Docket Nos.: STN 50-528, STN 50-529
and STN 50-530

SUBJECT: ISSUANCE OF AMENDMENT NO. 25 TO FACILITY OPERATING LICENSE NO. NPF-41, AMENDMENT NO. 14 TO FACILITY OPERATING LICENSE NO. NPF-51, AND AMENDMENT NO. 3 TO FACILITY OPERATING LICENSE NO. NPF-65, FOR THE PALO VERDE NUCLEAR GENERATING STATION, UNITS 1, 2 AND 3, RESPECTIVELY (TAC NOS. 65939, 65940 AND 65941)

The Amendments revise Section 6 of the Technical Specifications for each of the three Palo Verde Units to incorporate changes reflecting a revised organizational structure for the Palo Verde plant.

FIGURE 6.2-1
OFFSITE ORGANIZATION

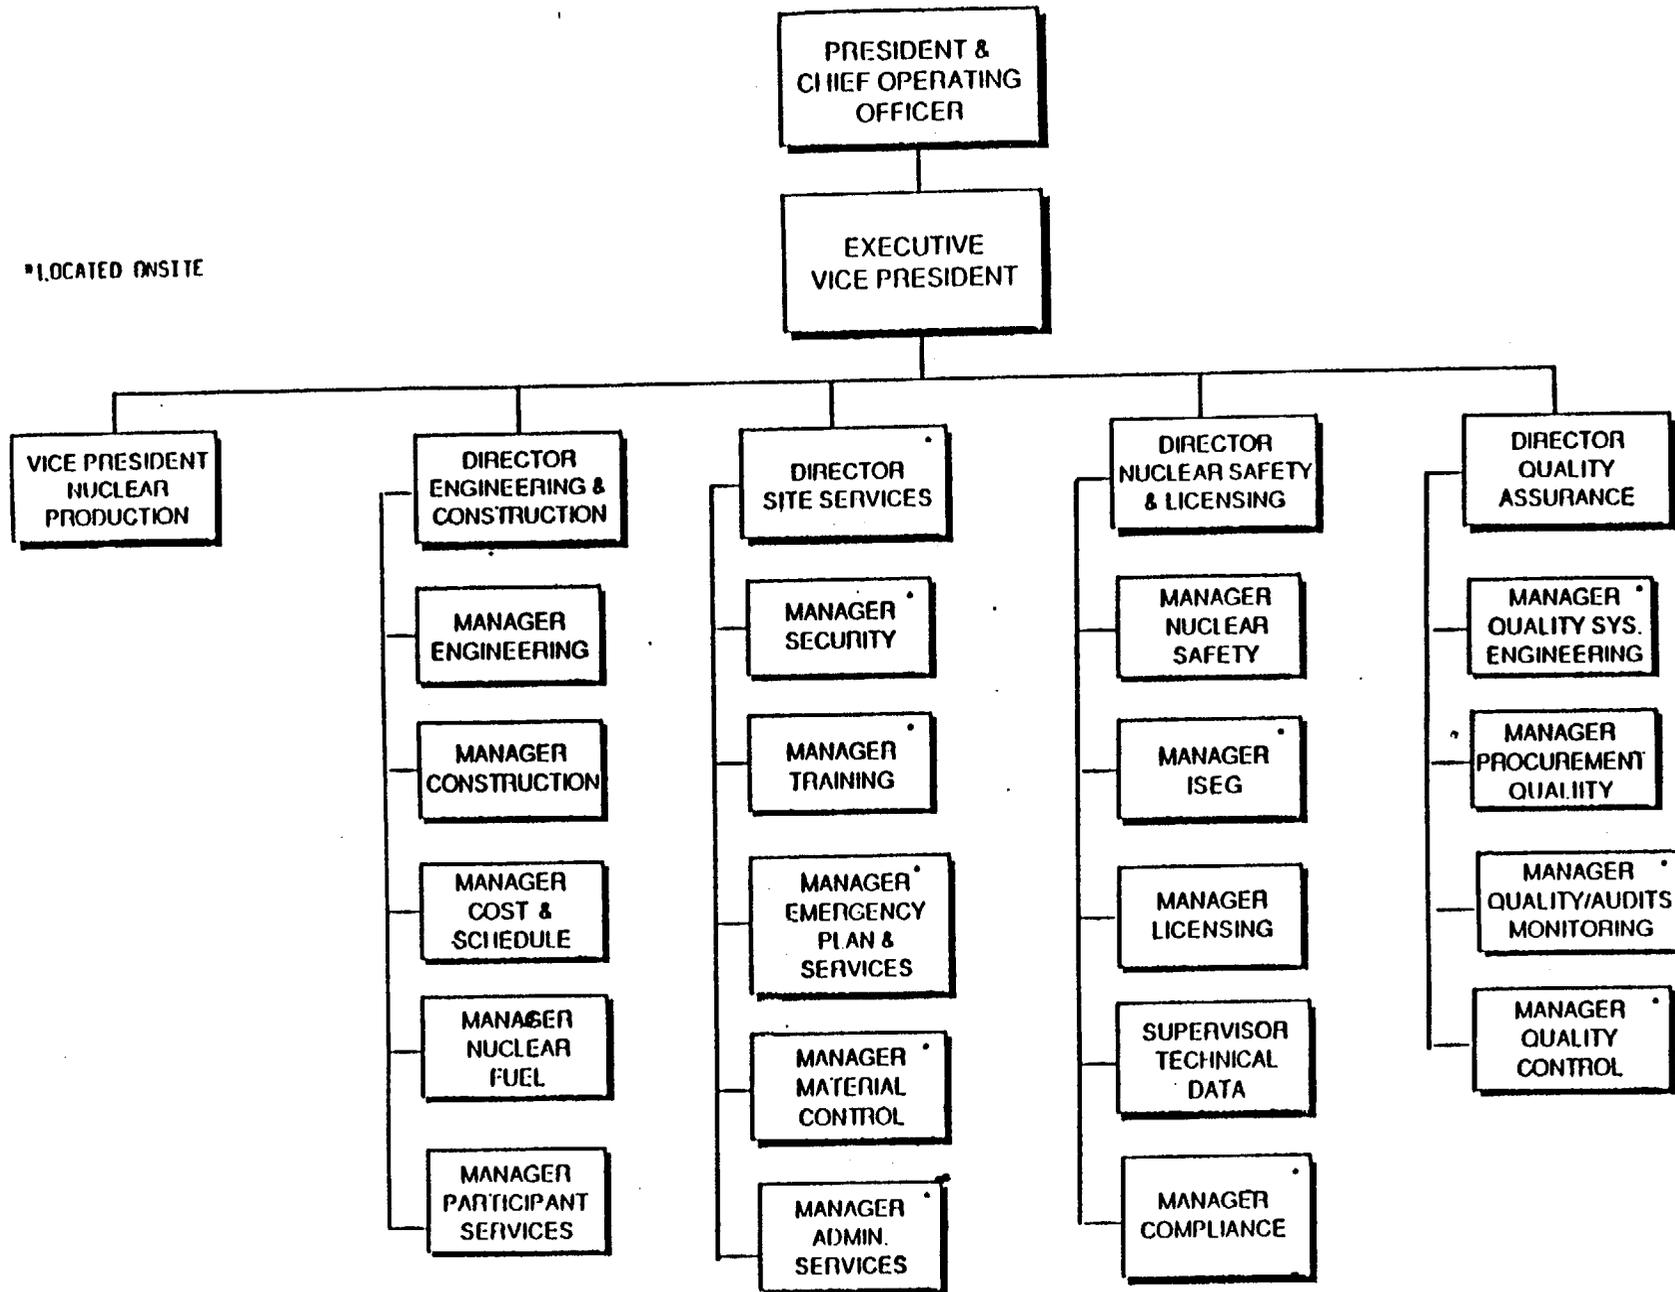
6.2.1 The offsite organization for unit management and technical support shall be as shown in Figure 6.2-1.

FIGURE 6.2-2

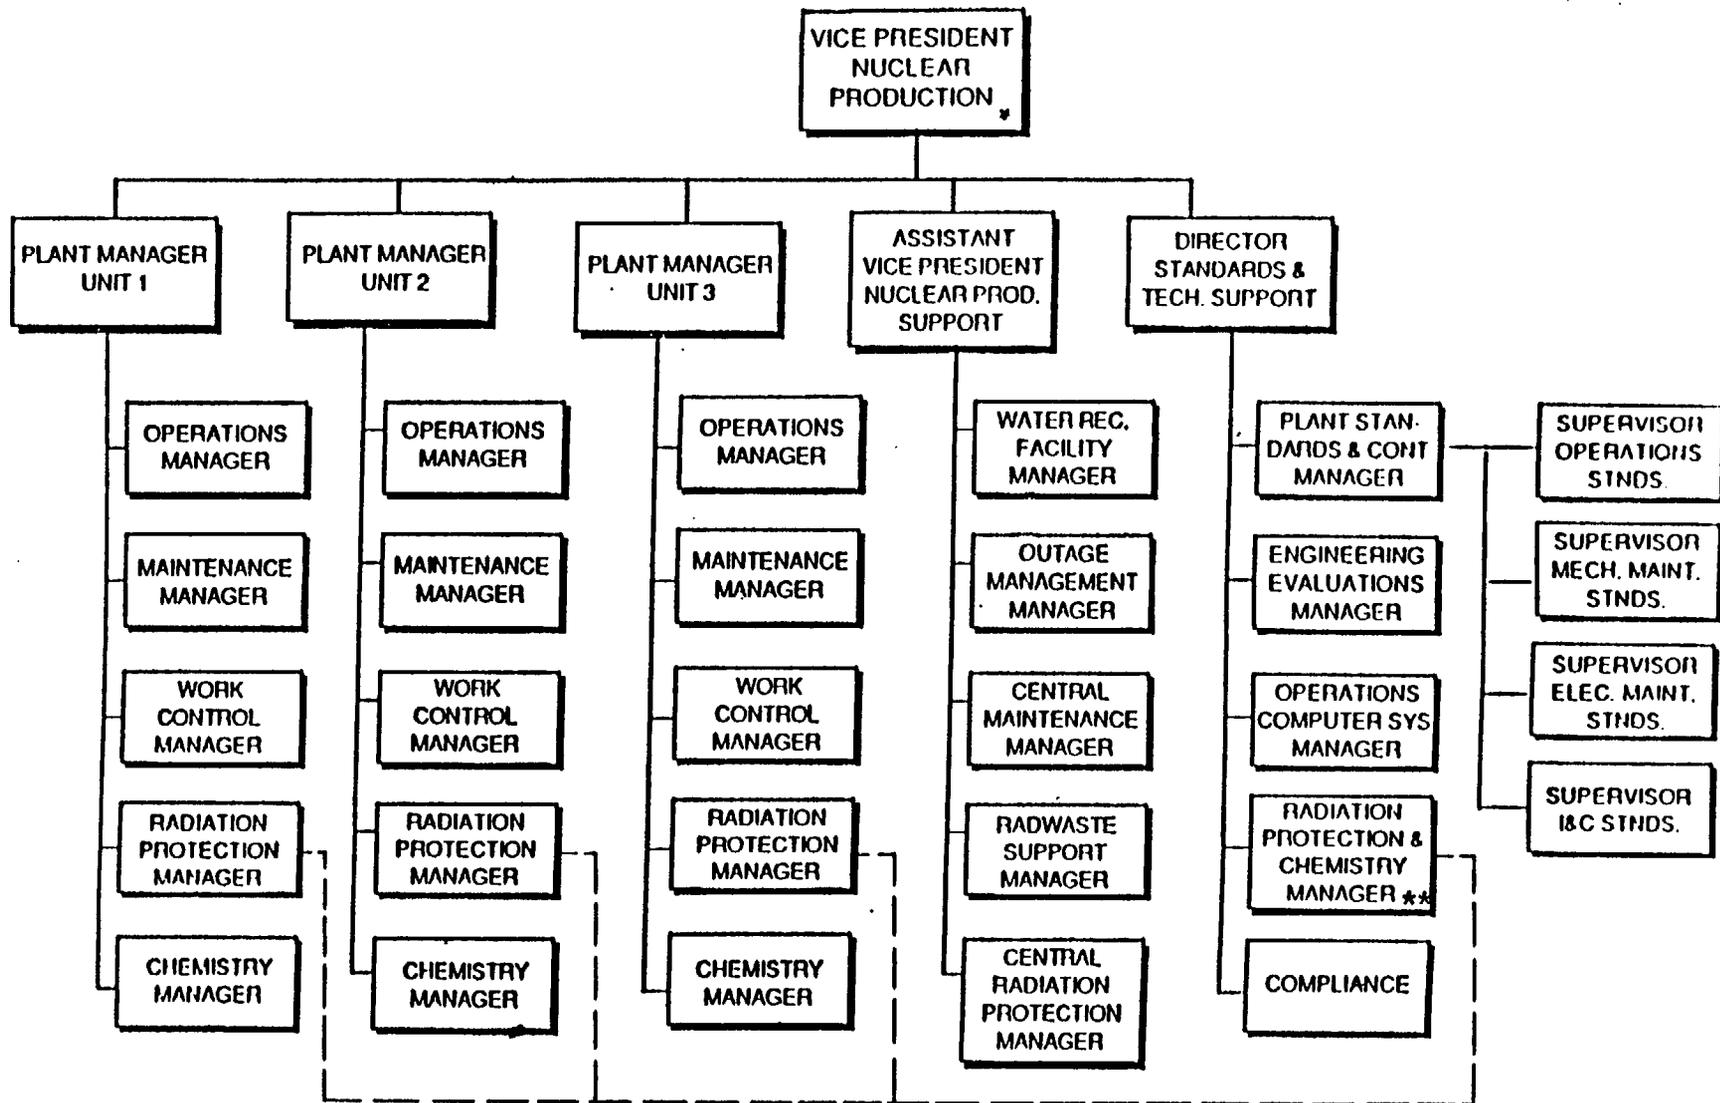
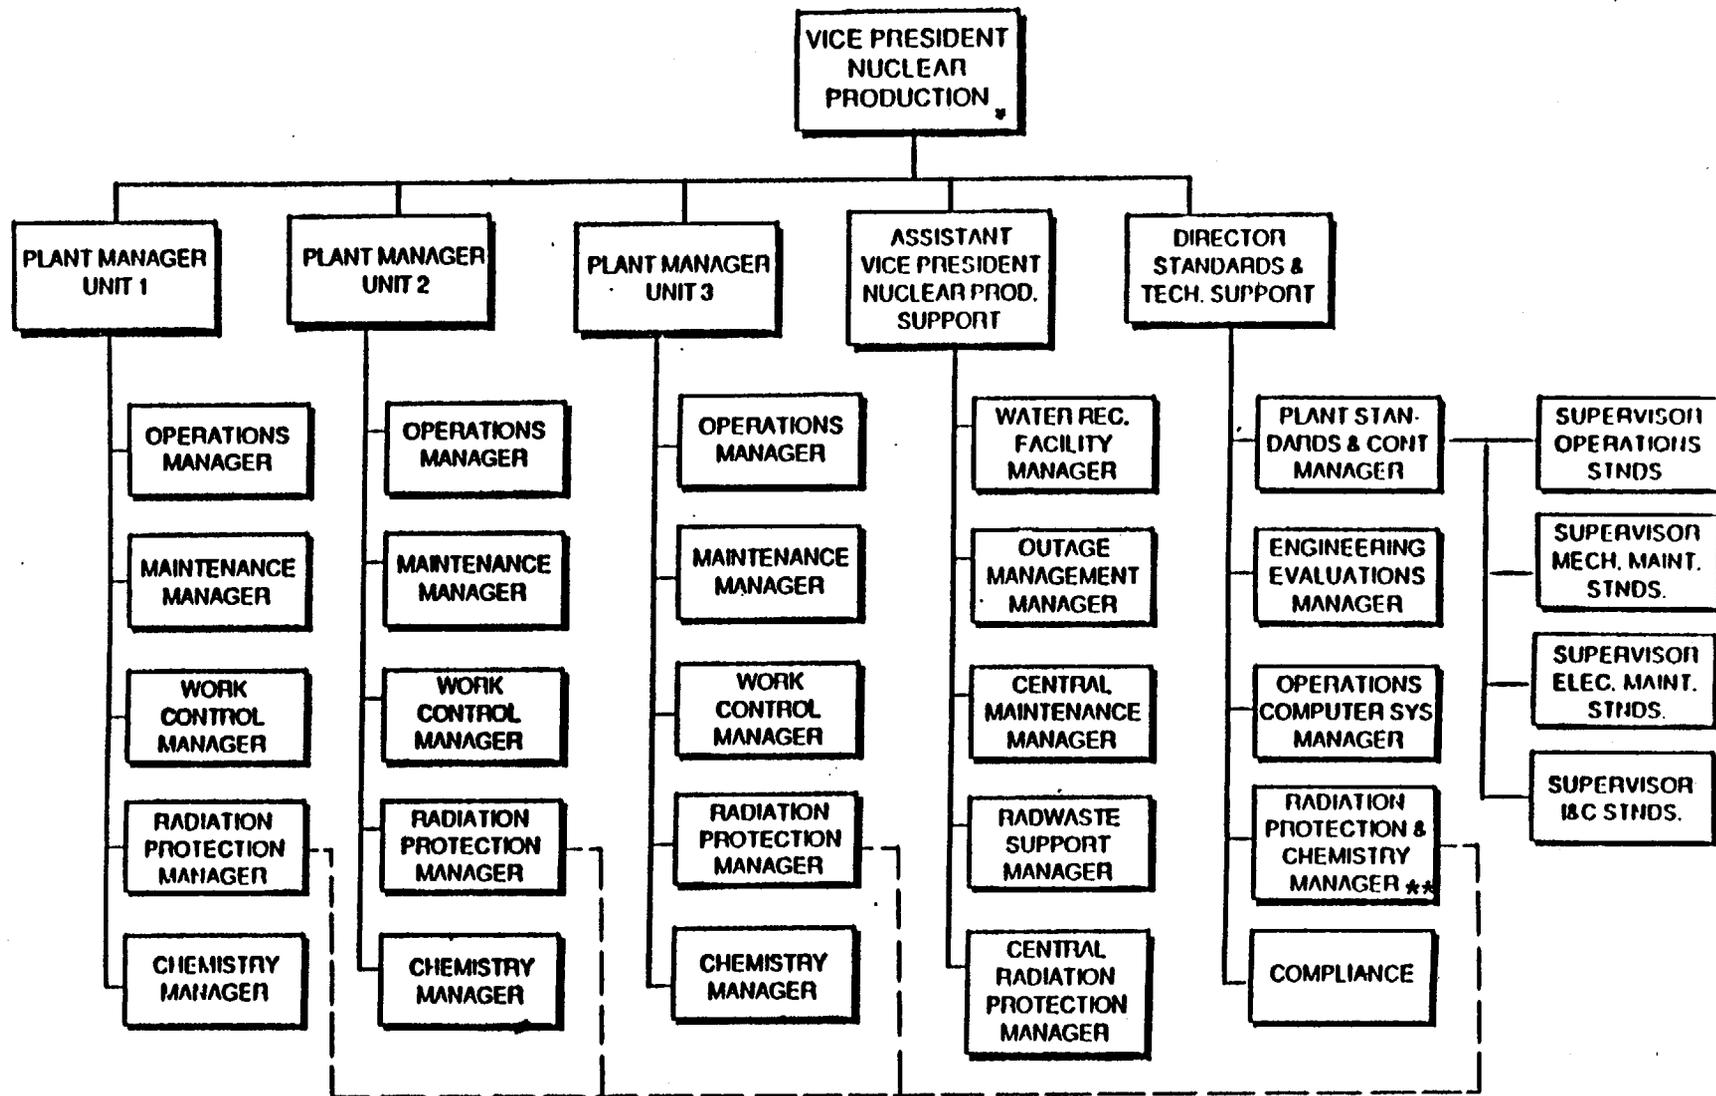
6.2.2.1 The unit organization shall be as shown in Figure 6.2-2 and:

FIGURE 6.2-1
OFFSITE ORGANIZATION

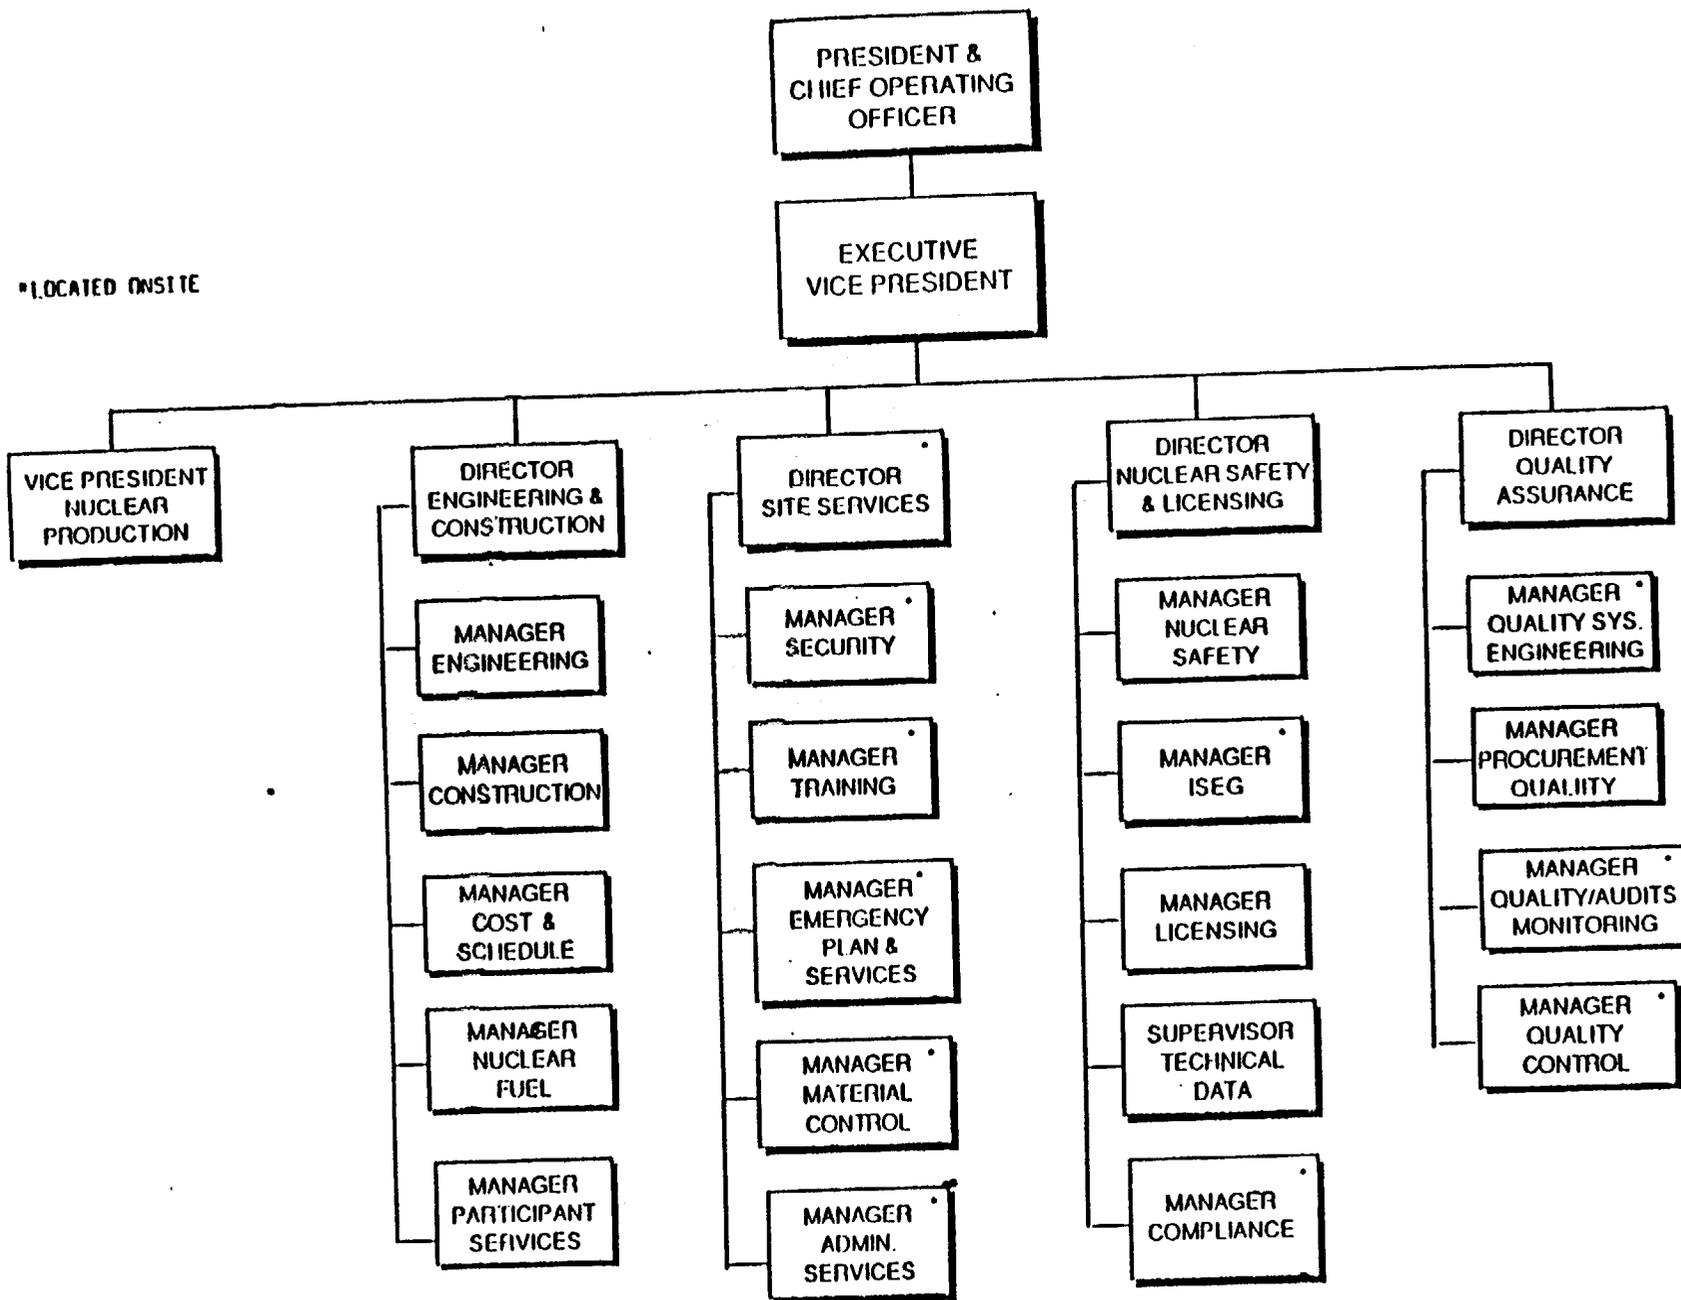
6.2.1 The offsite organization for unit management and technical support shall be as shown in Figure 6.2-1.
